ADDENDUM NO. 4**DATE: July 20, 2026**

PROJECT: HARMONY SCIENCE ACADEMY BRIDGELAND PHASE II MIDDLE-HIGH SCHOOL

**ARCHITECT'S PROJECT
NUMBER:** 06-22-014

A-002

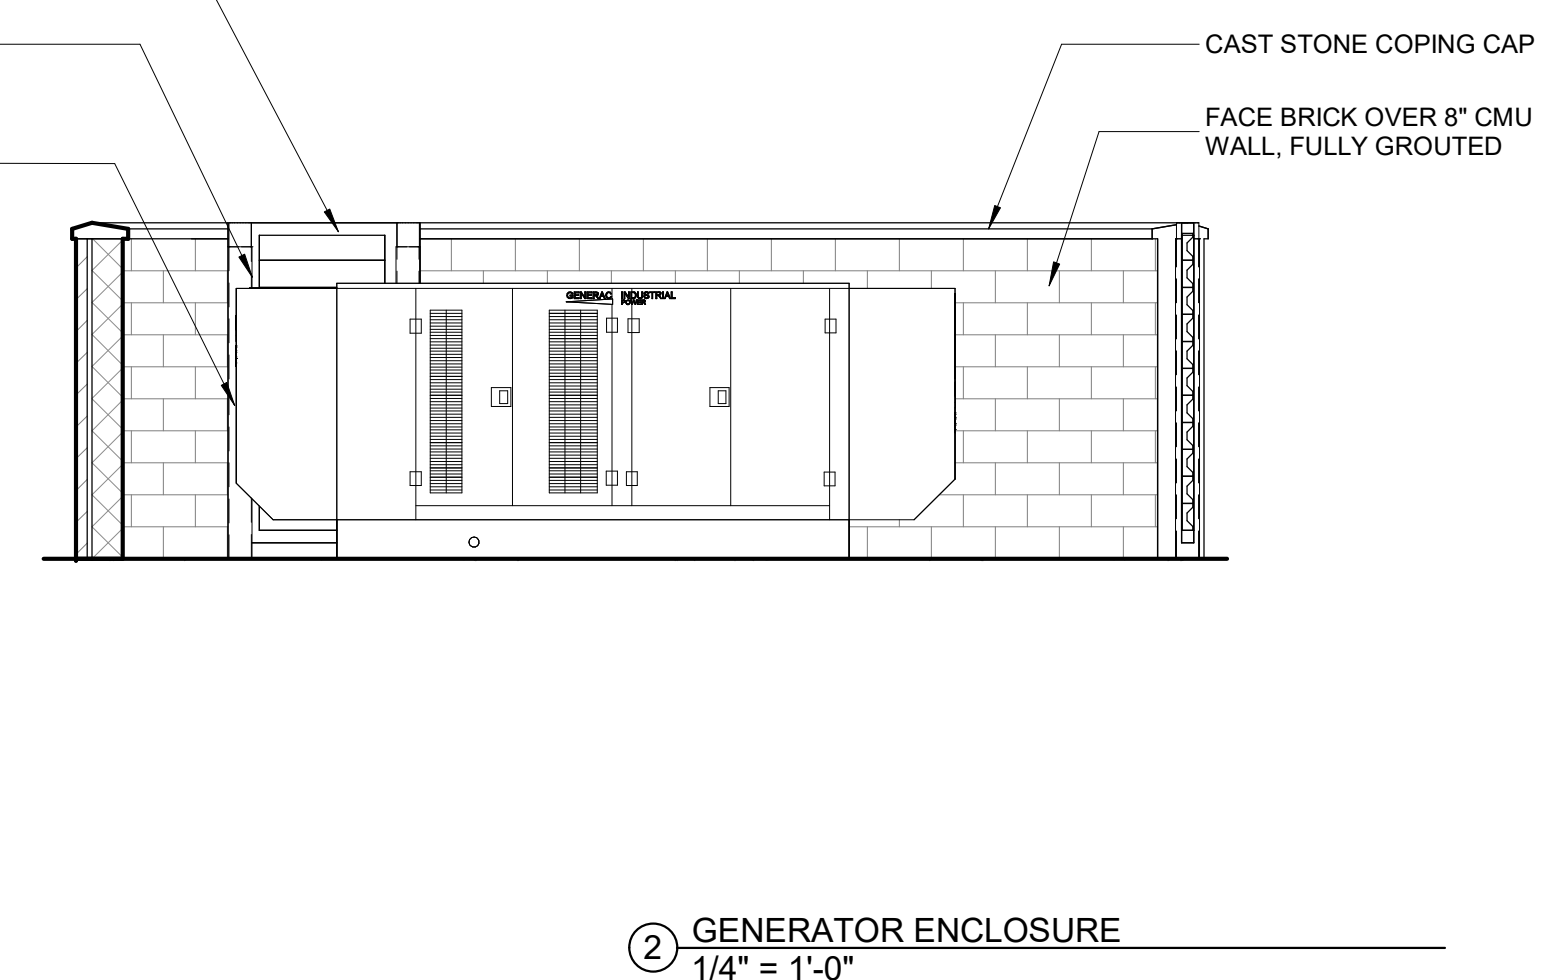
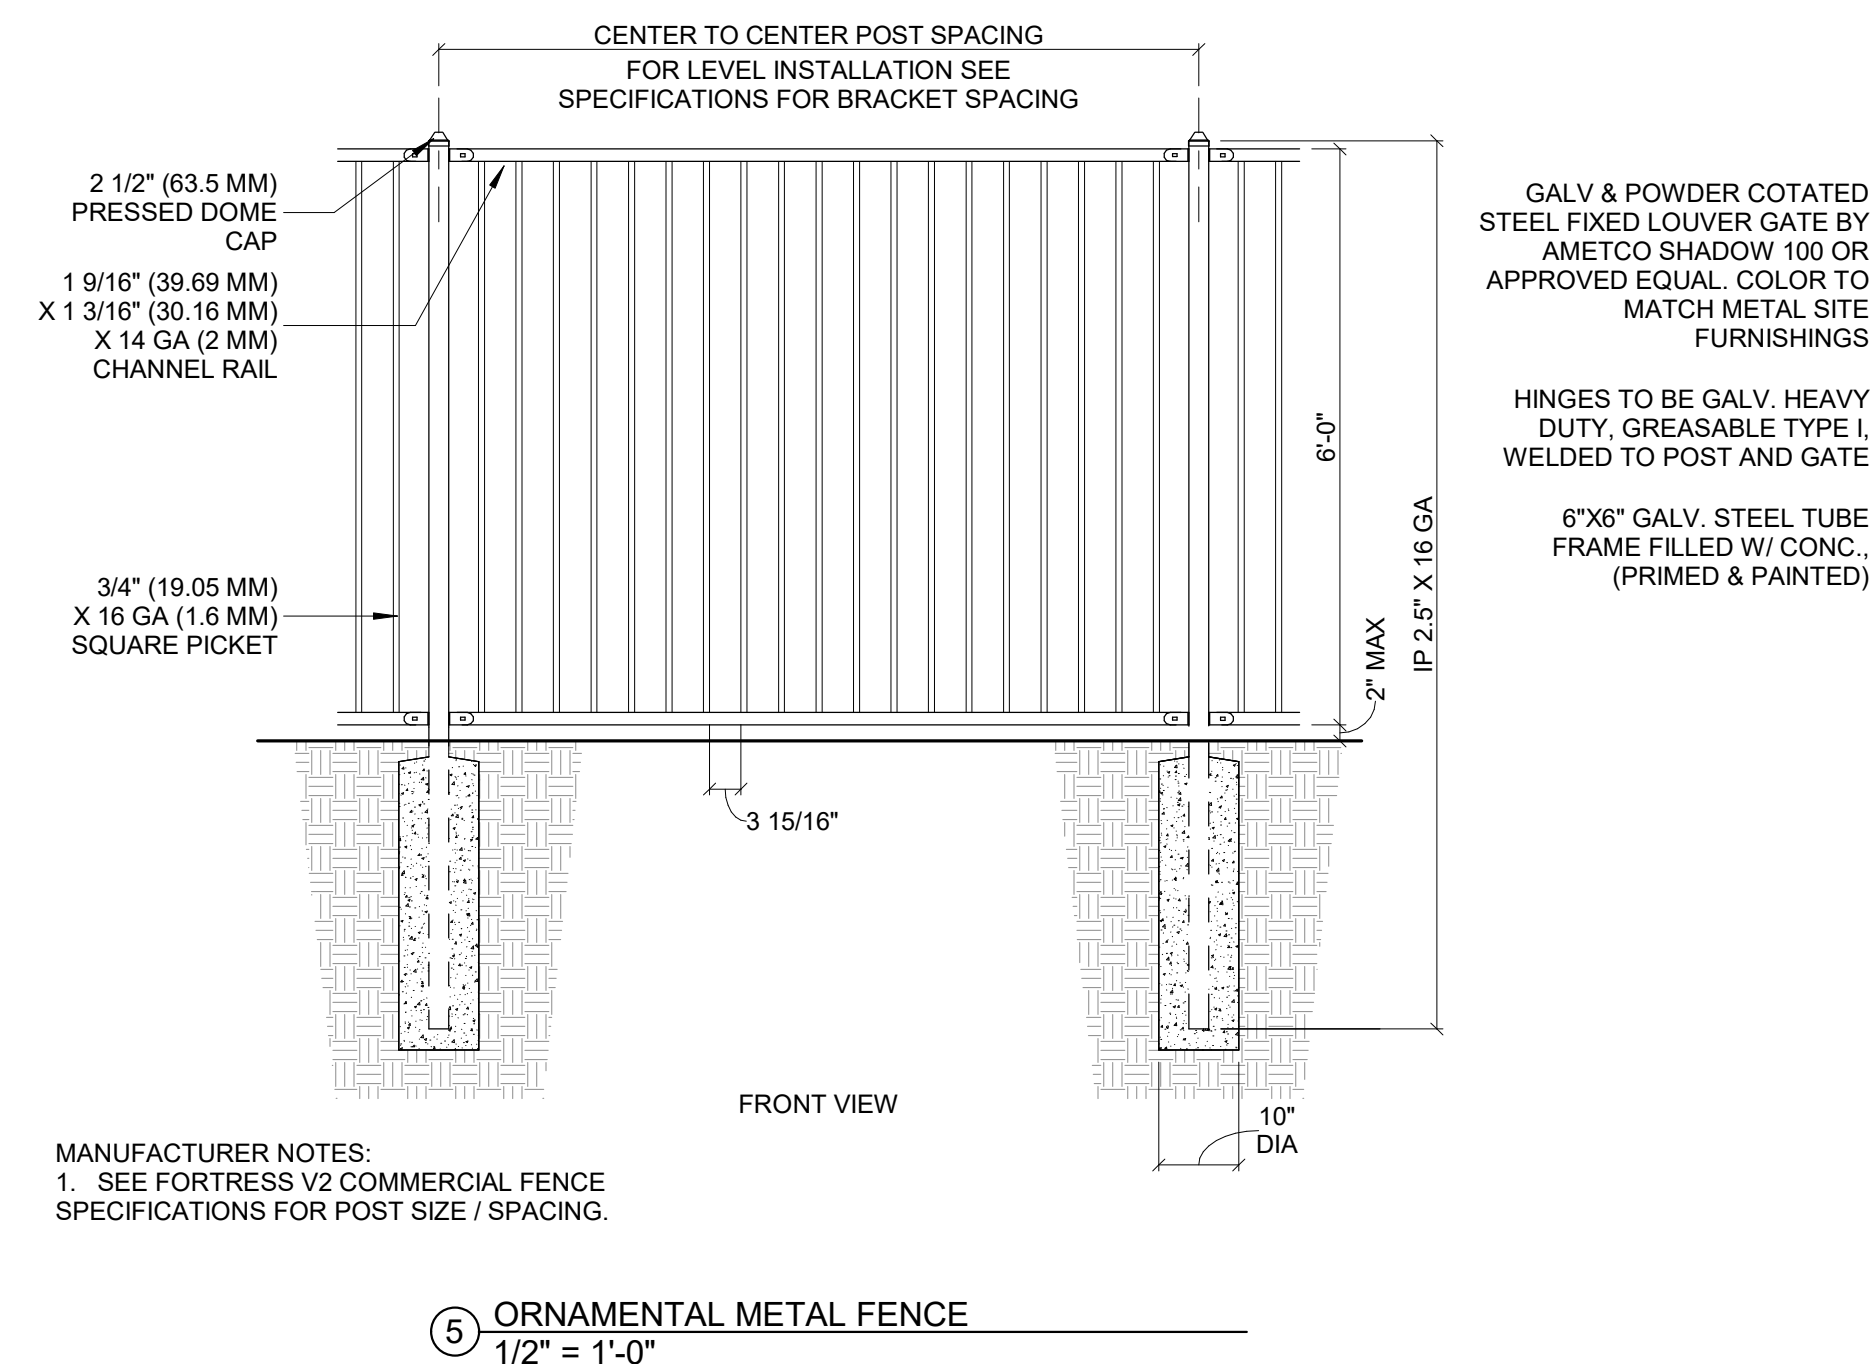
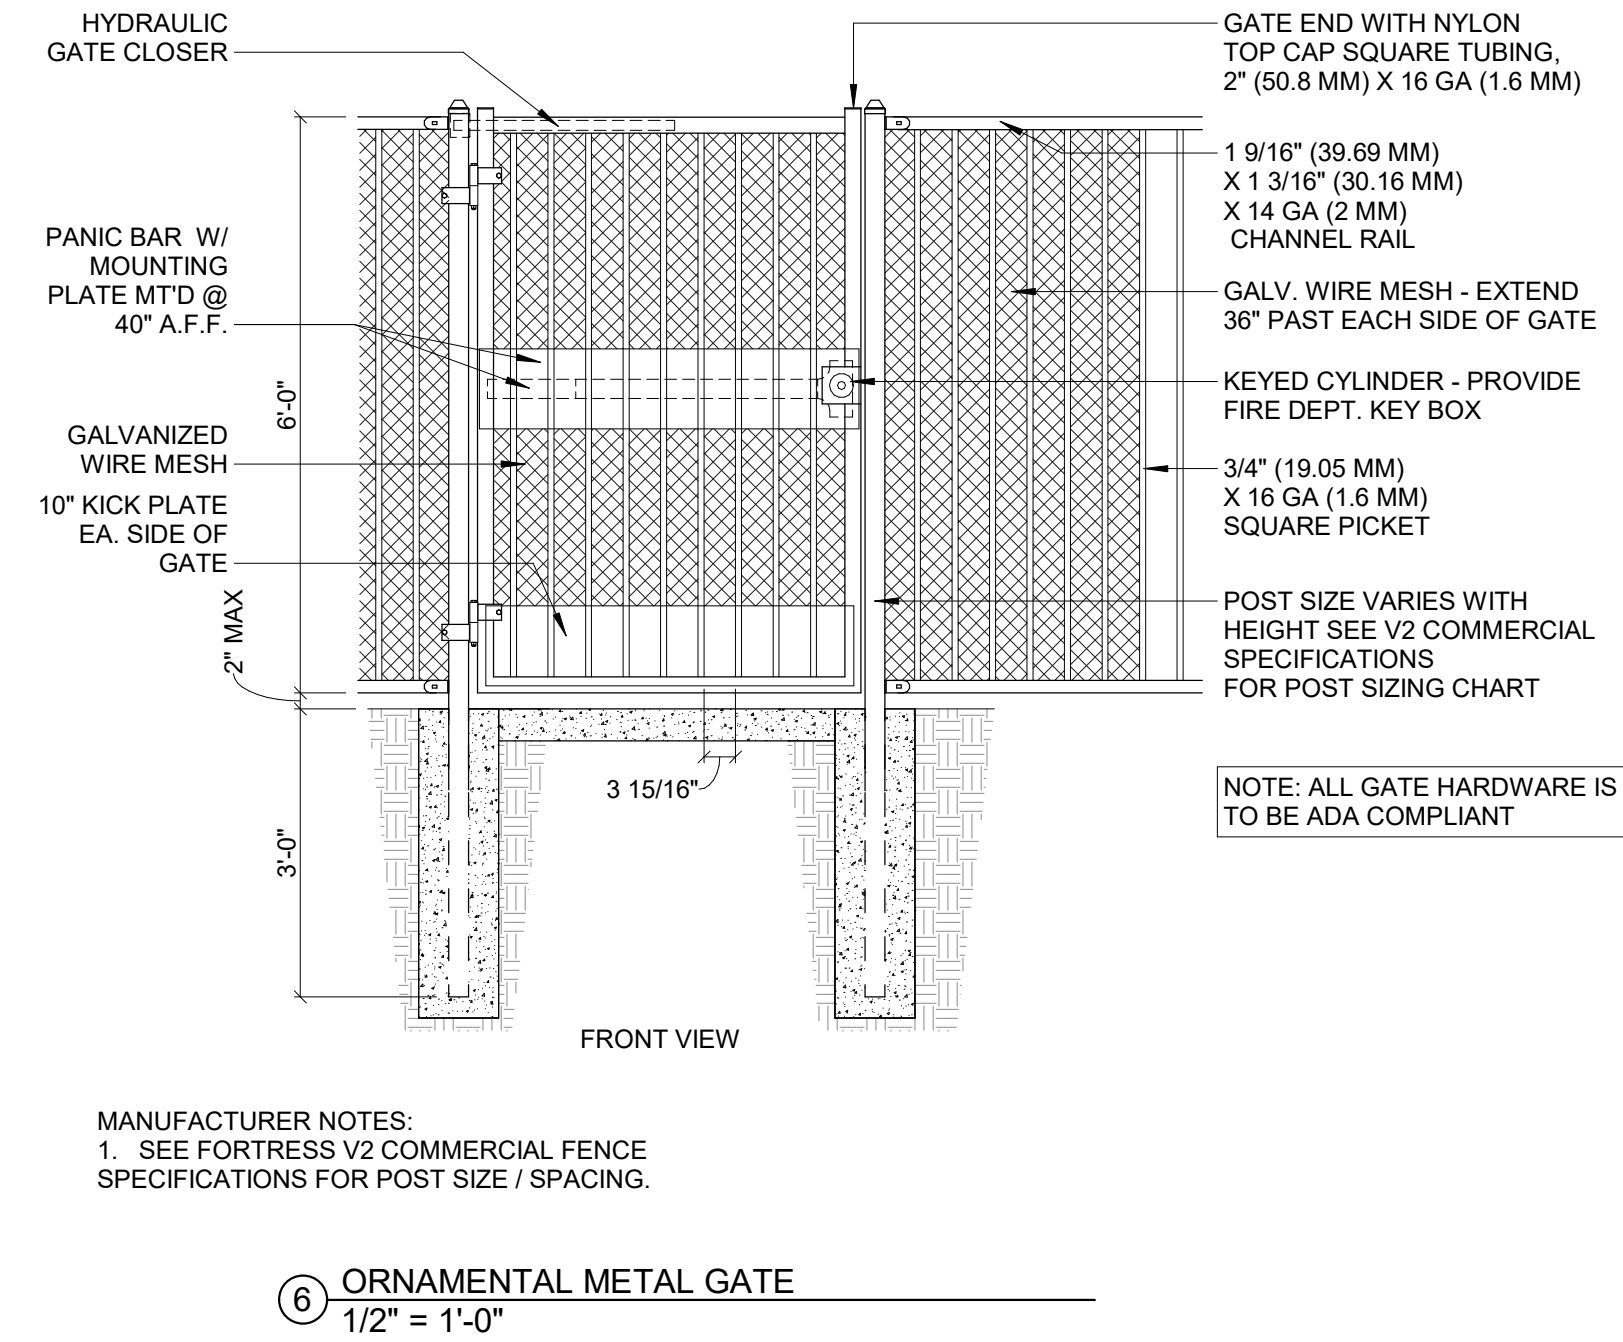
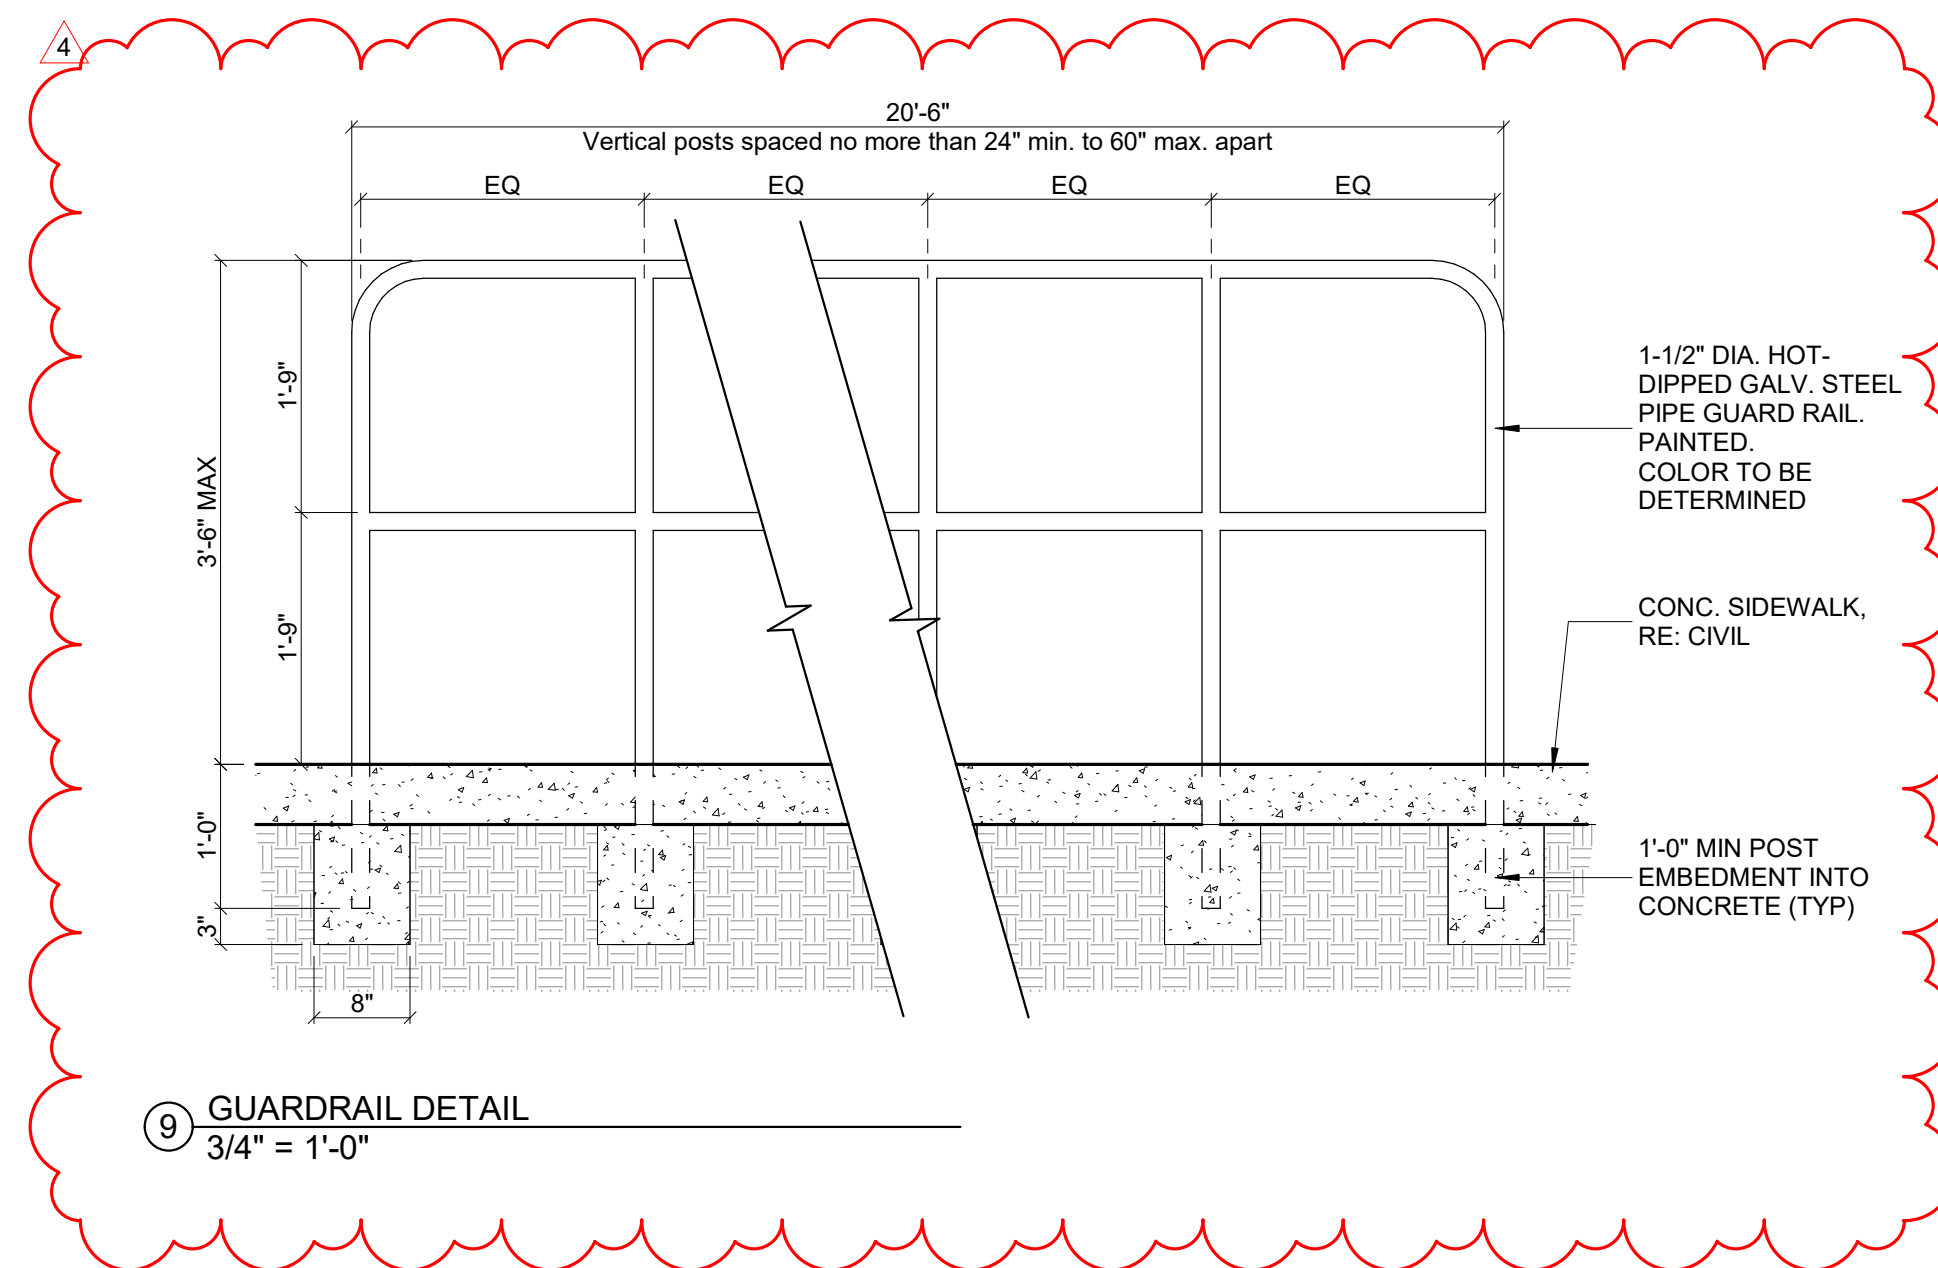
40. *Are any site furnishings such as trash receptacles, benches, tables, etc. required for this project? They have in the past but I don't see any on the plans.*

Response: Please see revised sheet A-002. There are 7 benches added and 3 trash cans.
